Project Feather River West Levee

Date January 13, 2016

Subject Recommendation for Levee Degrade at Cultural Site 10 I

Technical Memorandum

DRAWING NO. C-103 SHEET 22

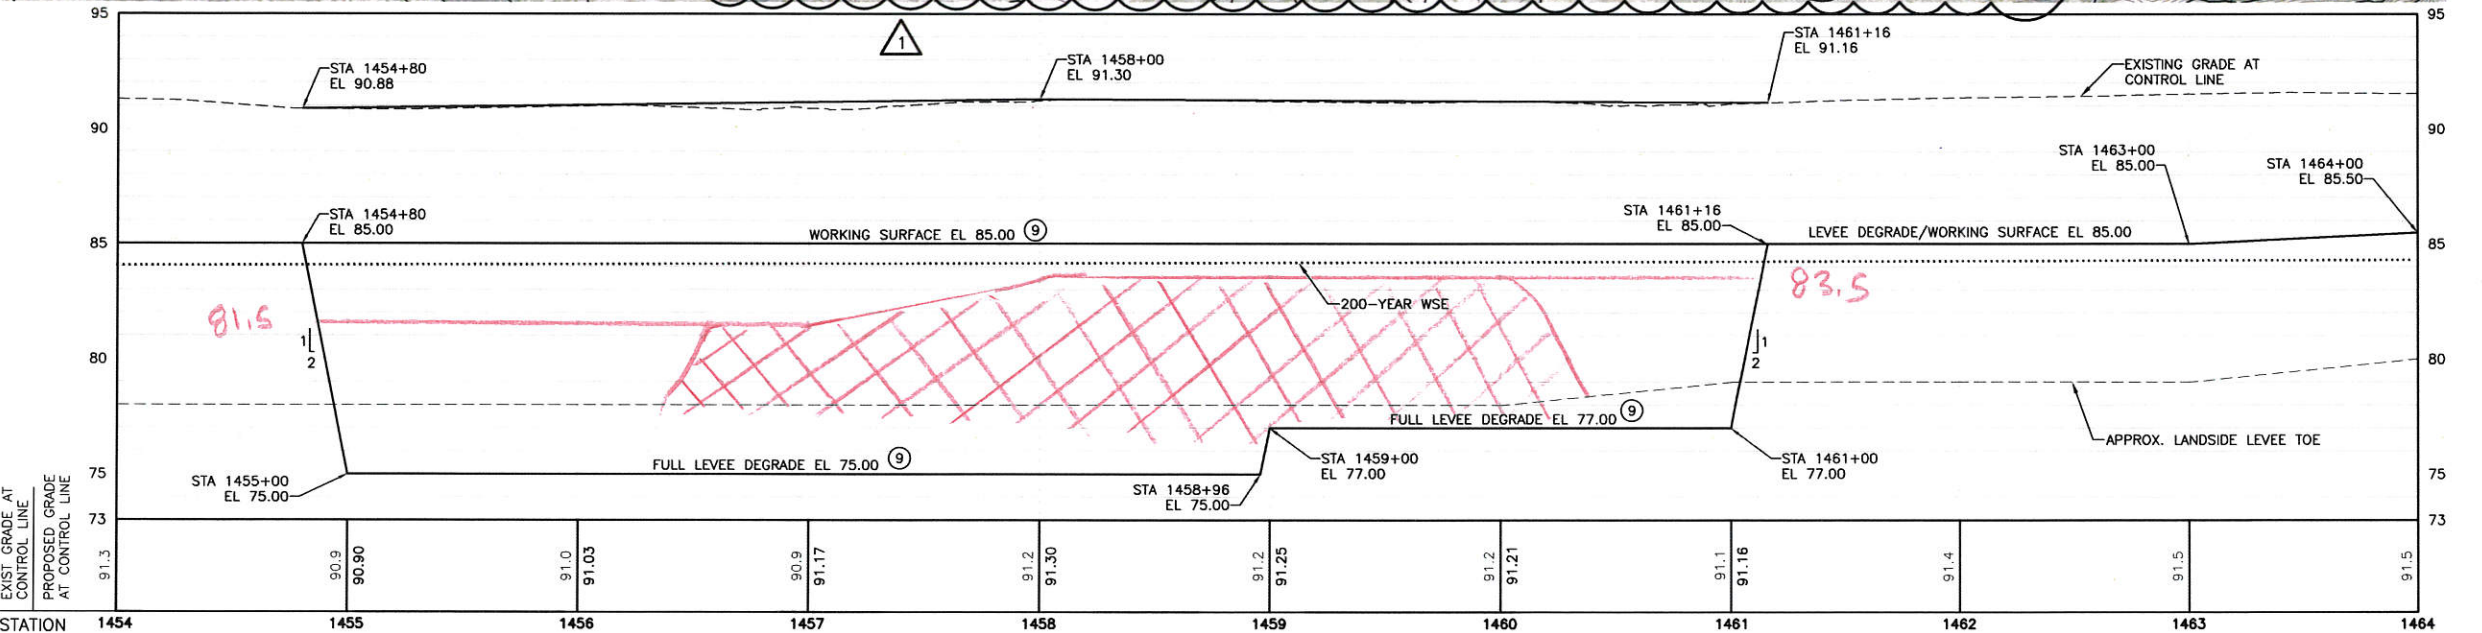
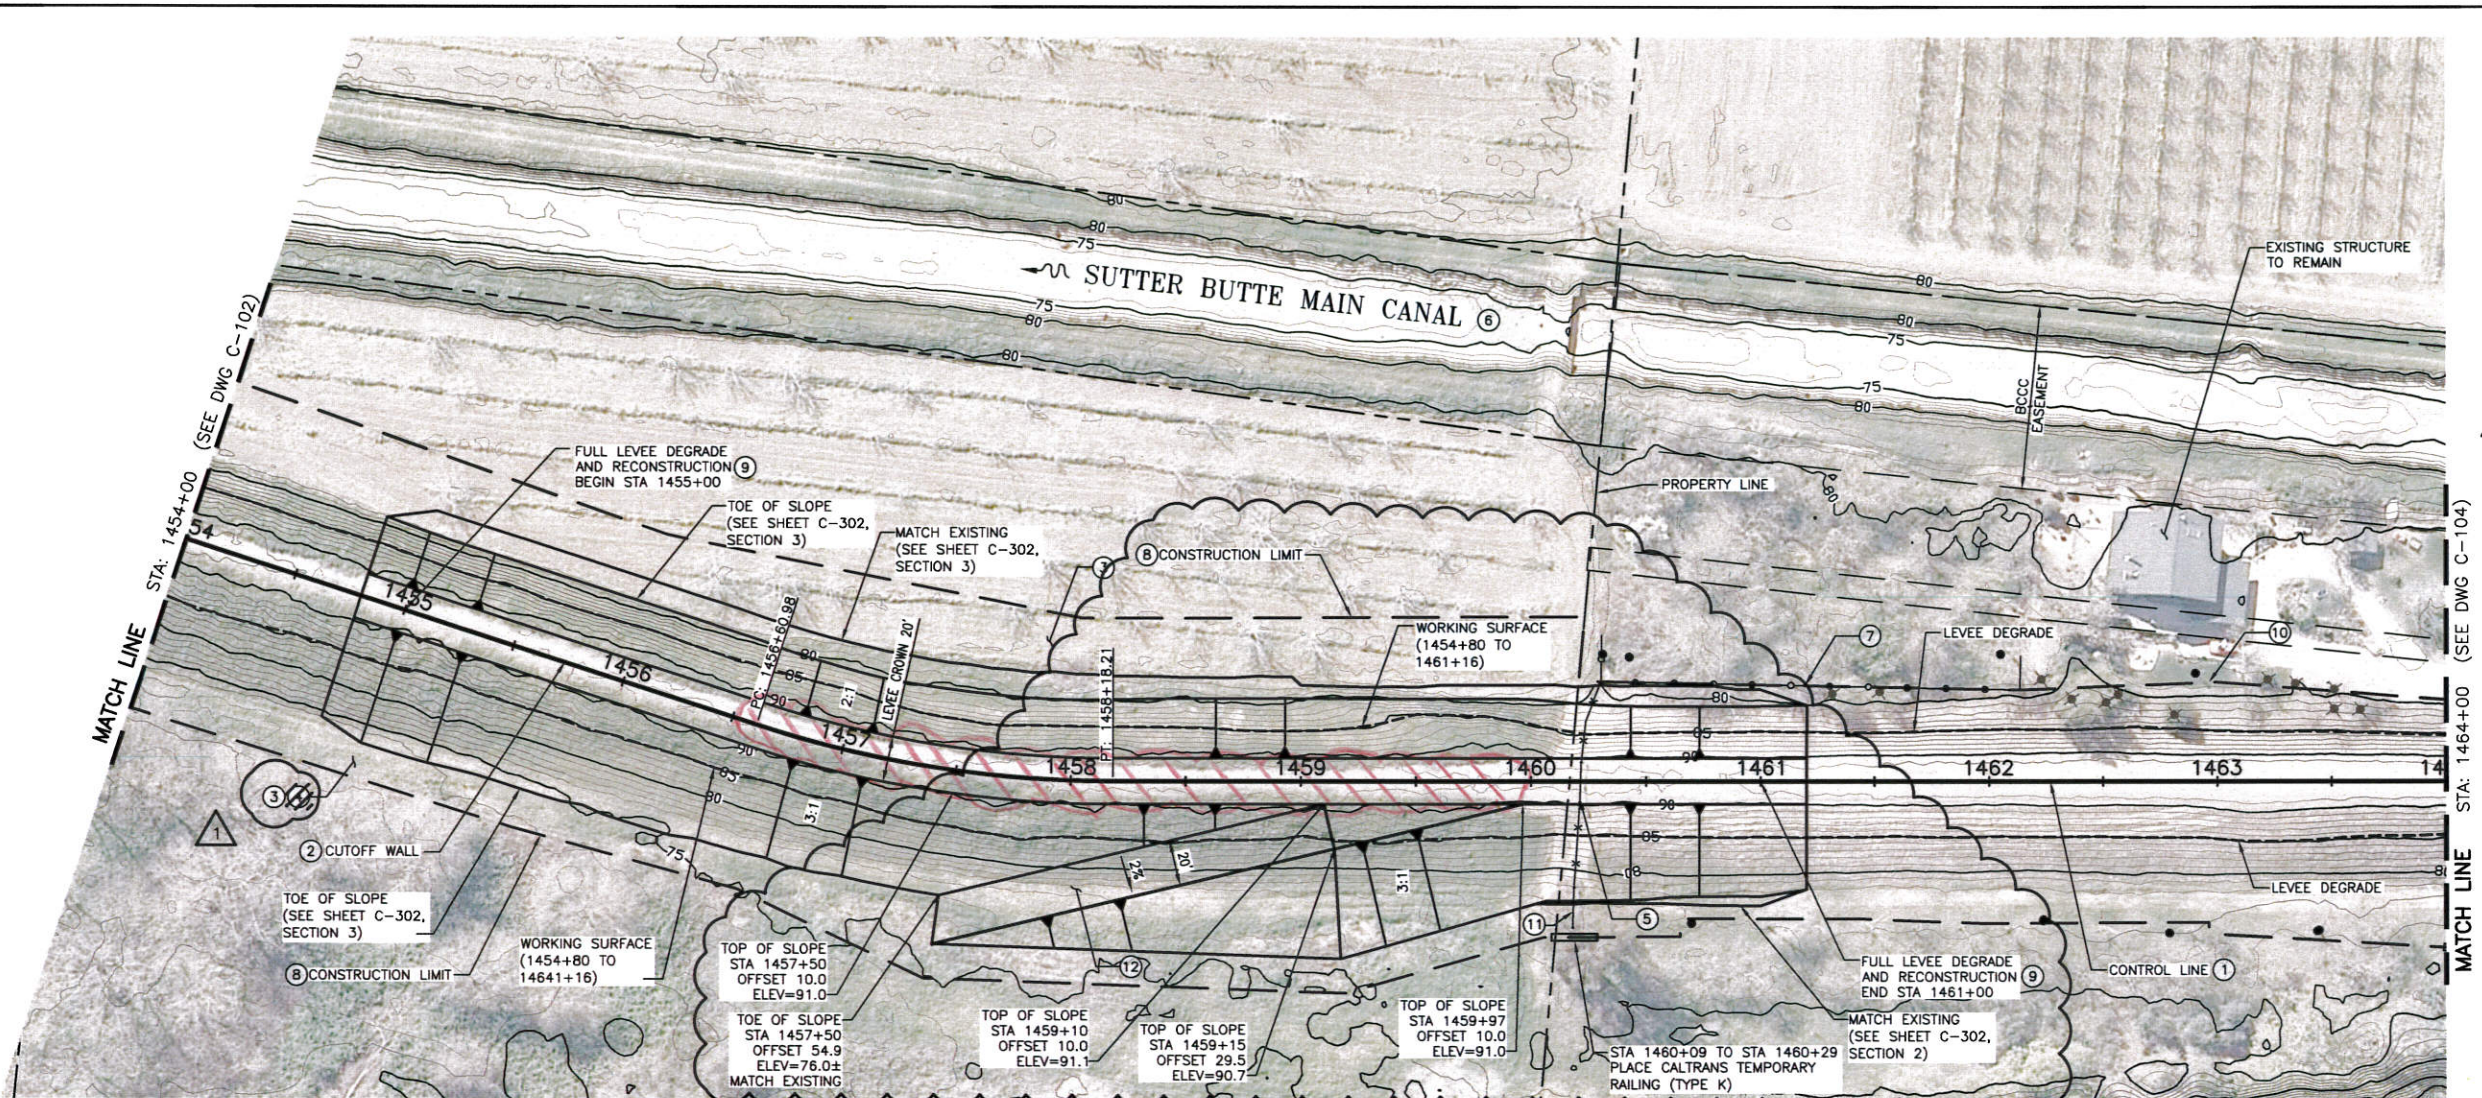
In addition to the removal and replacement work, a new access ramp was constructed on the waterside of the levee between approximately Station 1457+50 and 1460+00, which resulted in a significantly wider levee cross-section in this area. Refer to sketches in Attachment A for details.

TYPICAL CROSS SECTION STA 1455+00 to 1461+00

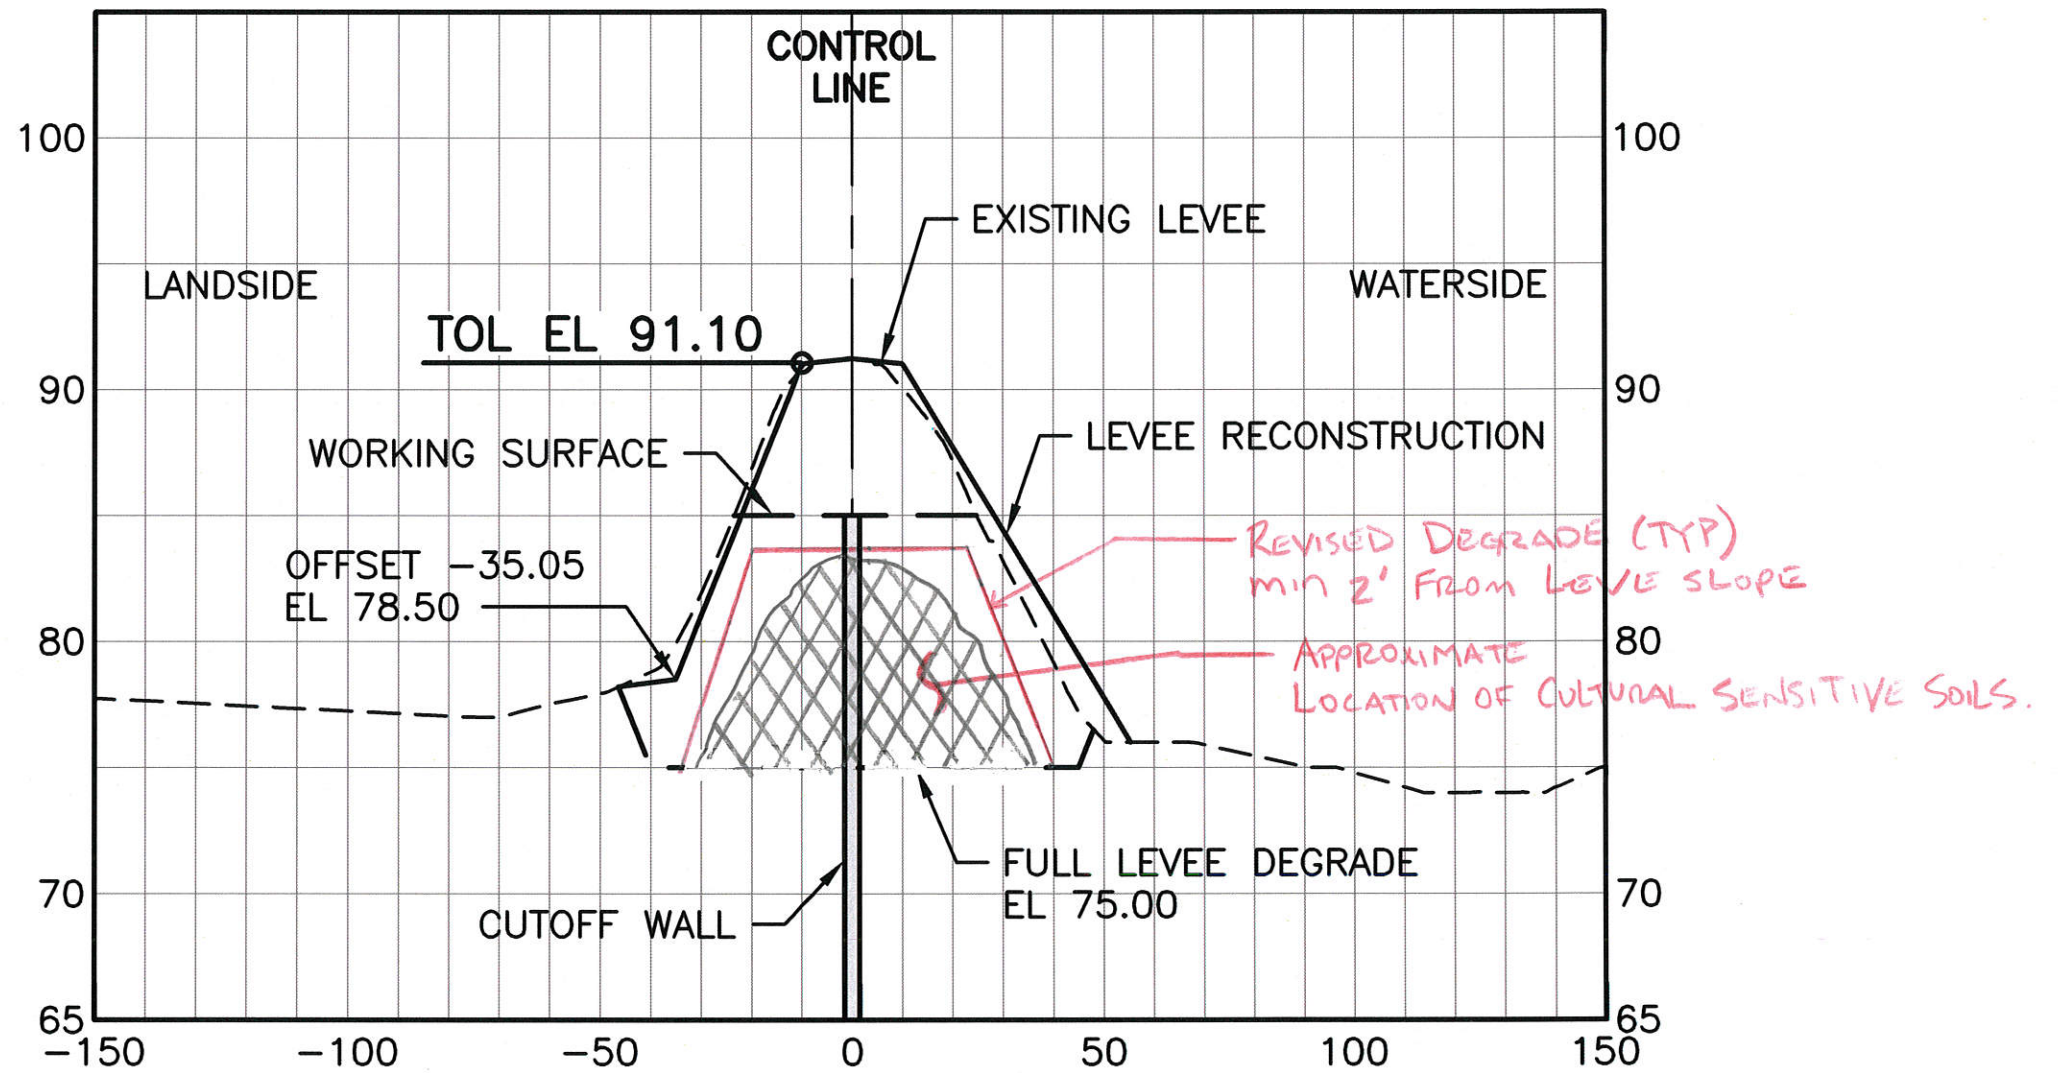
For the area between approximately Station 1455+00 and 1461+00, the original design called for a full levee degrade to address animal burrows that were identified in this section of the levee during the investigation phase. Following full degrade, the levee was to be rebuilt up to the elevation of the working platform and a cutoff wall installed.

Following observation of midden soils in the levee degrade, test pitting was performed to identify the approximate width of midden soil in center of the levee. This indicated that the midden soils were approximately 60 feet wide at the base of the levee and 20 feet wide below the working

platform. This compares to a levee width of approximately 110 feet at the base and 50 feet at the elevation of the working platform. Refer to sketches in Attachment A for details.

Based on the above and discussions with the project team and with DWR, it was recommended to remove the maximum amount of material on both the landside and waterside levee slopes as possible without impacting midden soils. Based on the cross-section of midden soils, this should create a compacted zone at least 10 feet thick on either side of the levee. To address cases where midden soils were potentially wider in the levee profile, a minimum width of removal of 2 feet beyond the 0.5 foot stripping limit was specified.

FILL KEY AND BENCHING DETAIL
NTS

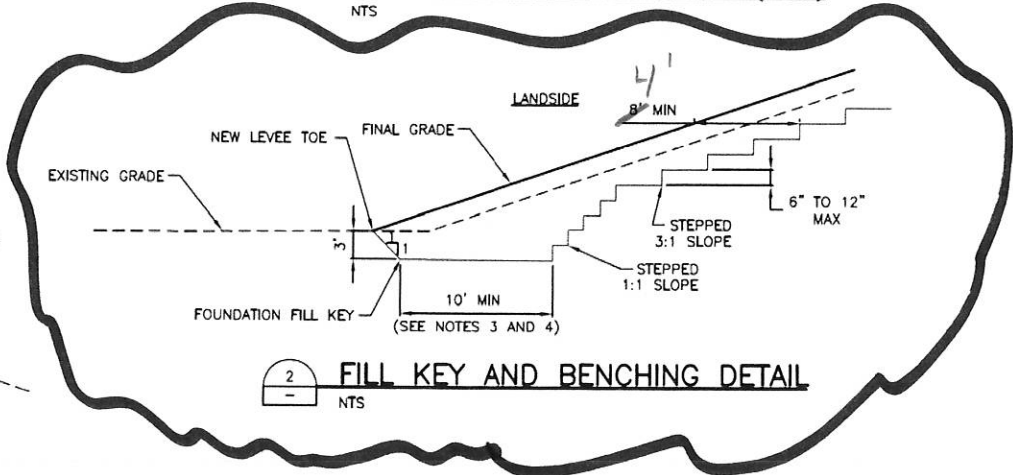
Following removal of material, the excavated side slopes were to be benched in accordance with the "Fill Key and Benching Detail" shown on Drawing No. C-303, Sheet 43, of the design drawings prior to placement and compaction of backfill materials.
